Access Compliance Report

Public Rights-of-Way

(Curb Ramps)

Intersection ID: 2848	Main Street: DOWNFIELD_WOOD_DR	Cross Street: TUPELO_LN	Location: NE
ADA ID: 7D2D22708BE1	Ramp Type: Perp	Initial Pass/Fail: Fail	Overall Compliance: No
Codes/Mitigation Info/Possible Solution			Severity Score: 22.5
			Field Measurements/Component Compliance

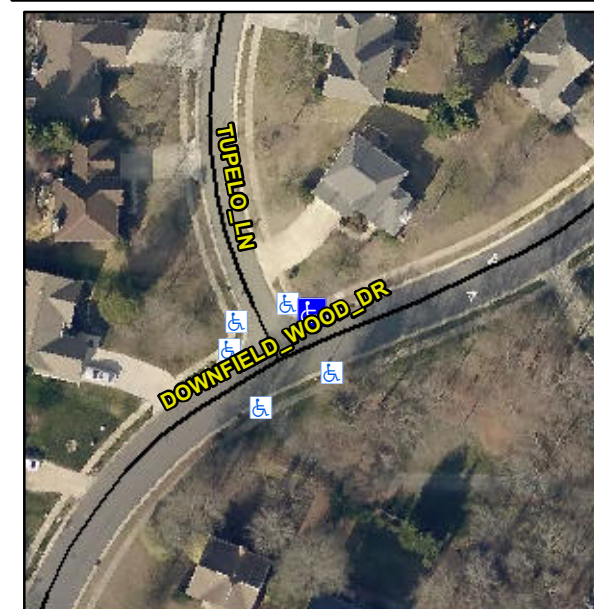
R304.5.1, R304.2.2, R304.5.3

Compliance	Description	Data	Compliance	Description	Data
N/A	Ramp Length (in)	47.0	No	Ramp Slope (%)	11.3
No	Ramp Width (in)	47.0	No	Ramp XSlope (%)	2.3
N/A	Flare Type LT	N/A	N/A	Flare Type RT	N/A
N/A	Flare Slope LT (%)	N/A	N/A	Flare Slope RT (%)	N/A
N/A	Flare Traversable LT?	N/A	N/A	Flare Traversable RT?	N/A
N/A	Landing Length (in)	N/A	N/A	DWS Provided?	N/A
N/A	Landing Width (in)	N/A	N/A	DWS Contrast?	N/A
N/A	Landing Slope (%)	N/A	N/A	DWS Length (in)	N/A
N/A	Landing X Slope (%)	N/A	N/A	DWS Full Width?	N/A
N/A	Landing Curb? (Y/N)	N/A	N/A	DWS Offset (in)	N/A
N/A	Shared Landing?	N/A			
N/A	Gutter Ponding?	N/A	N/A	Gutter Slope (%)	N/A
N/A	Gutter Lip Ht (in)	N/A	N/A	Gutter X Slope (%)	N/A
N/A	Painted X Walk1?	No	N/A	Painted X Walk2?	N/A
	X Walk 1 Direction	To S		X Walk 2 Direction	N/A
N/A	X Walk 1 Width (in)	N/A	N/A	X Walk 2 Width (in)	N/A
	X Walk 1 Slope (%)	6.5		X Walk 2 Slope (%)	N/A
	X Walk 1 X Slope (%)	0.4		X Walk 2 X Slope (%)	N/A

Remove & Replace Entire Ramp.
